RFQ CCC-039 Instructional Building #1 - ADDENDUM 1

(FOR PRE-BID USE ONLY)
PRE-BID REQUEST FOR INFORMATION
COMPTON COMMUNITY COLLEGE DISTRICT
Send to ckober@pcm3.com ONLY!

Date of Pre-Bid RFI: <u>09/20/2018</u> Project Name: Instructional Building 1 Project No: CCC-039 Bid Package No.: N/A Bid Package Description: N/A	Bidder Name: GB Construction, Inc. _____ _____
---	--

10

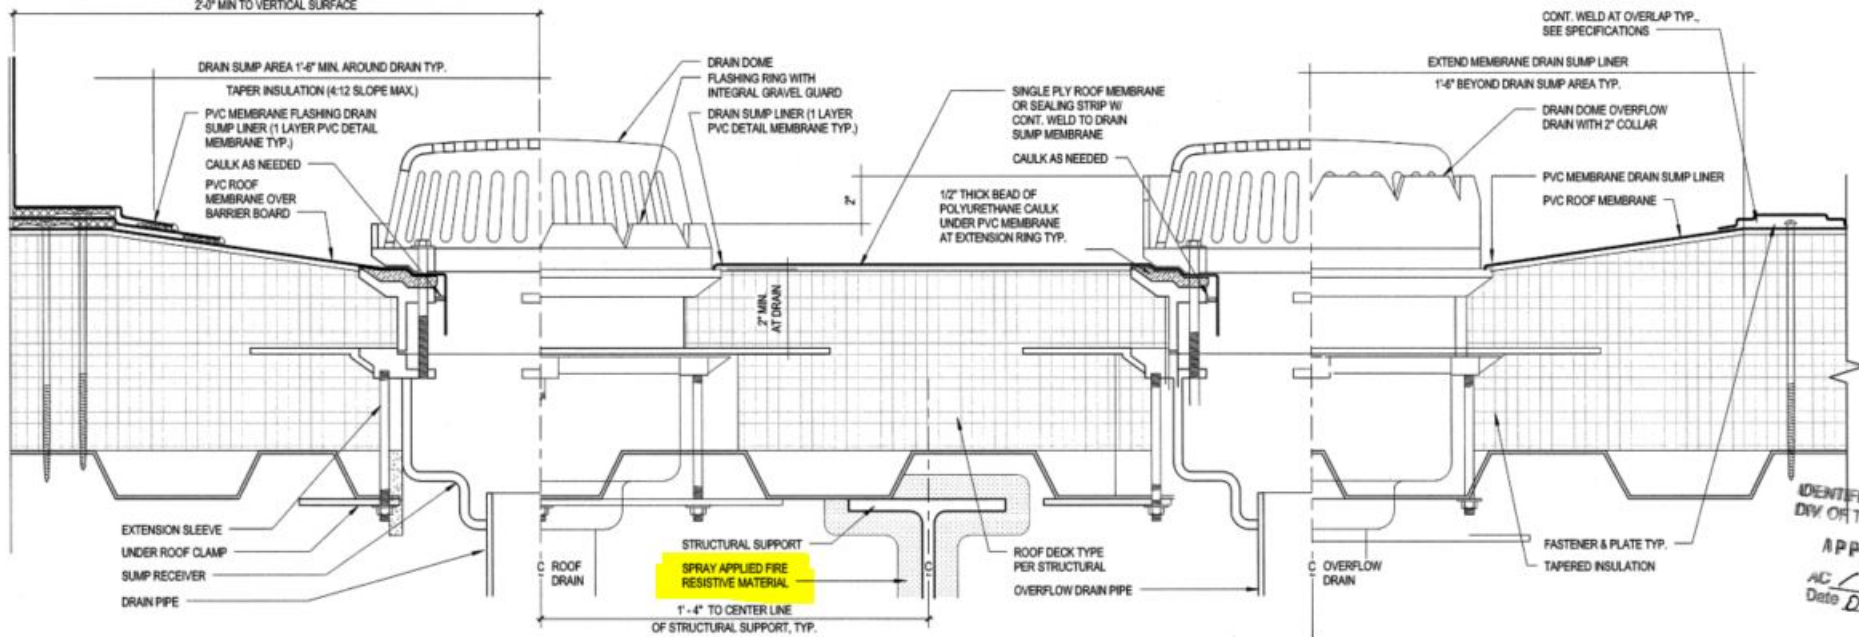
Per Architectural drawing A8.03 and A10.01, fireproofing material is being called out.

Please provide the specification for the fireproofing material.

Fireproofing of the structural steel is not required per "Fire Resistive Construction - Type II-B" of the Code Analysis on sheet CP1.01. Contractor to ignore fireproofing illustrated around structural steel and/or metal decking indicated in the document details.

10 1 HR SHAFT AT EDGE OF SLAB
SCALE: 1 1/2" = 1'-0"

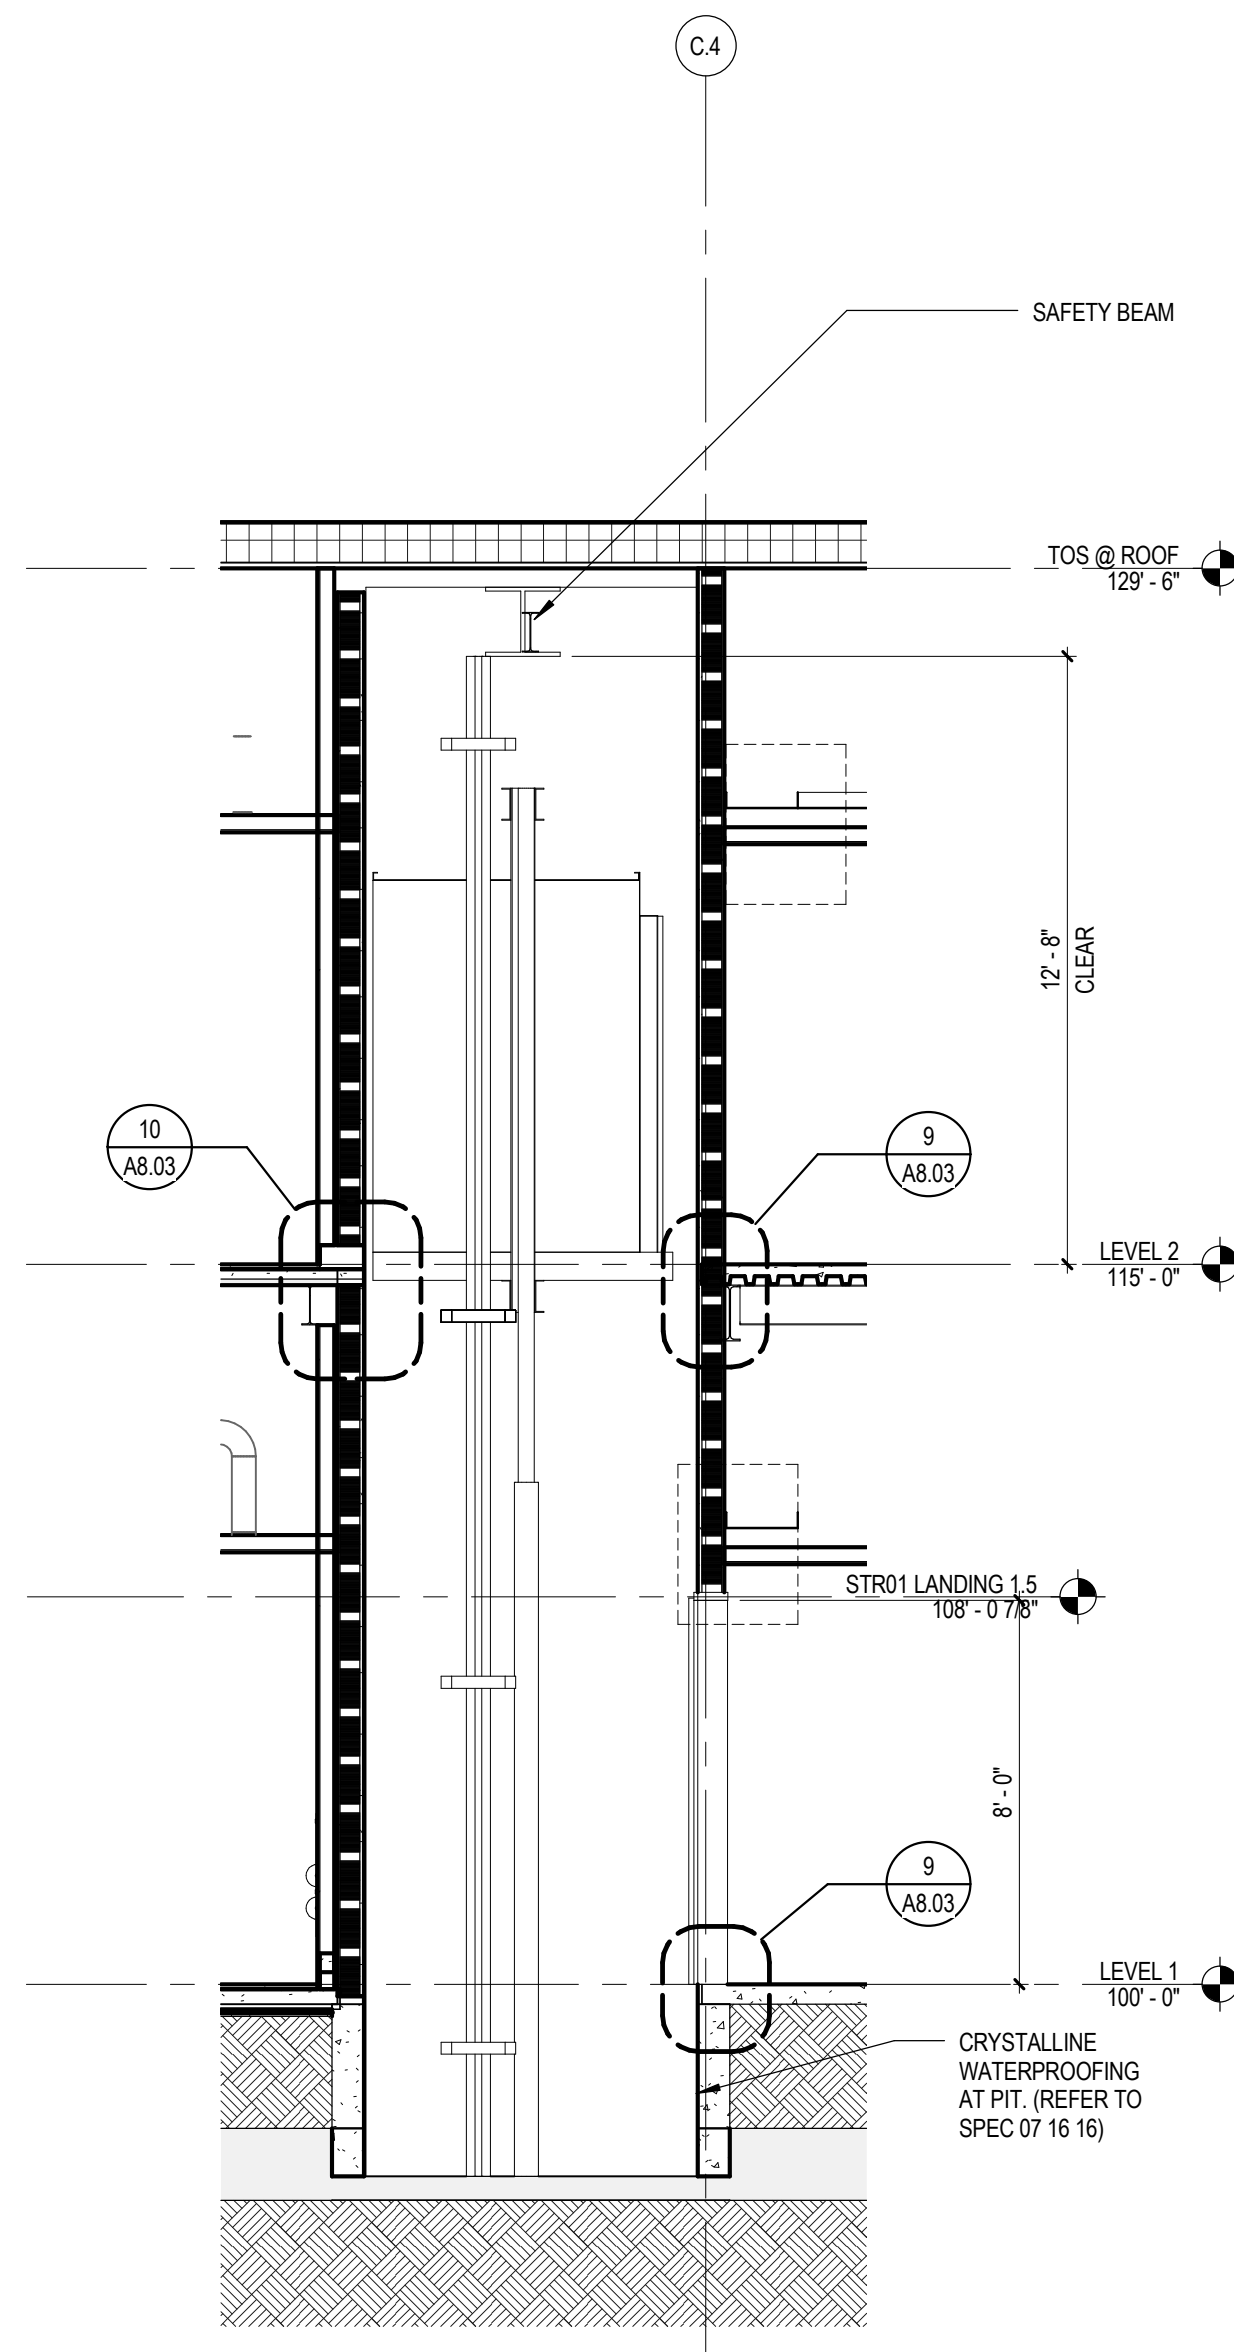
- A. Revised Detail 10/A8.03 – 1-HR SHAFT EDGE OF SLAB: Concrete curb adjusted, Detail callout 3/A9.01 added, keynotes added.

14 SECURITY FENCE SILL
SCALE: 3" = 1'-0"

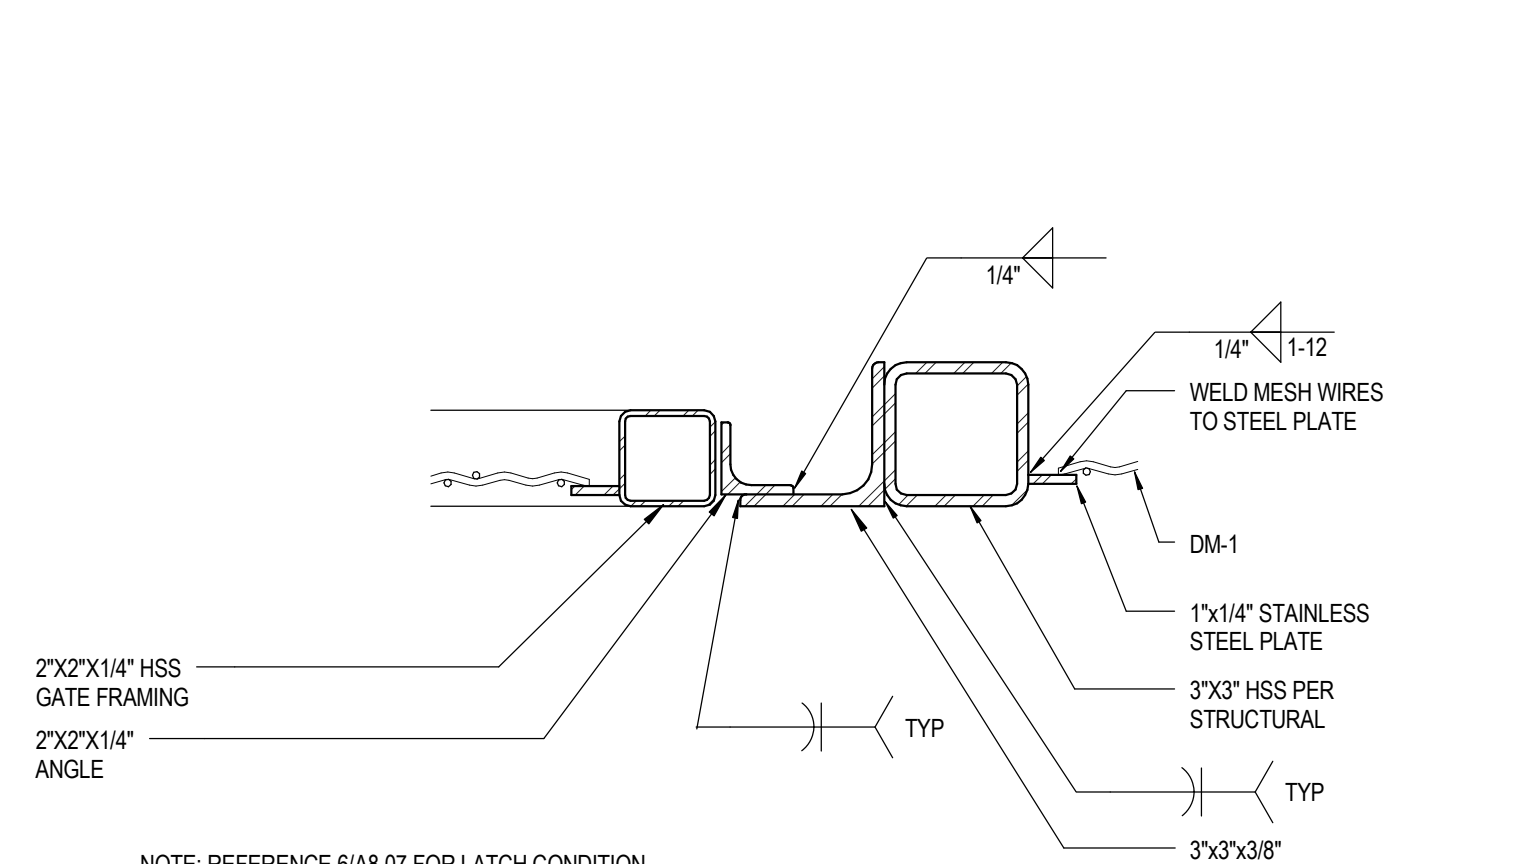
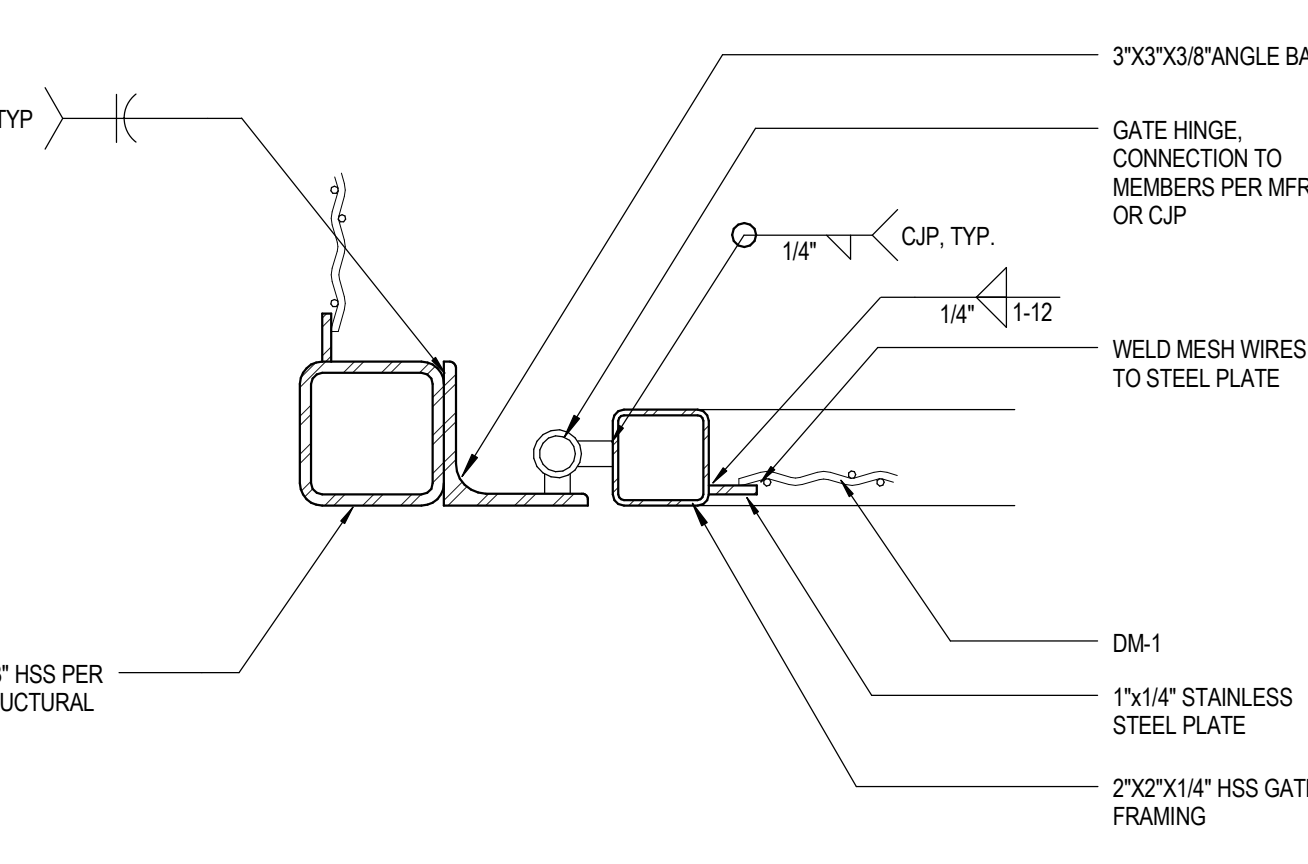
- B. Revised Detail 8/A8.07 – SECURITY FENCE SILL: Added weld symbols to attachment of 3"x3" HSS to HSS Tube and Cap Plate to HSS.
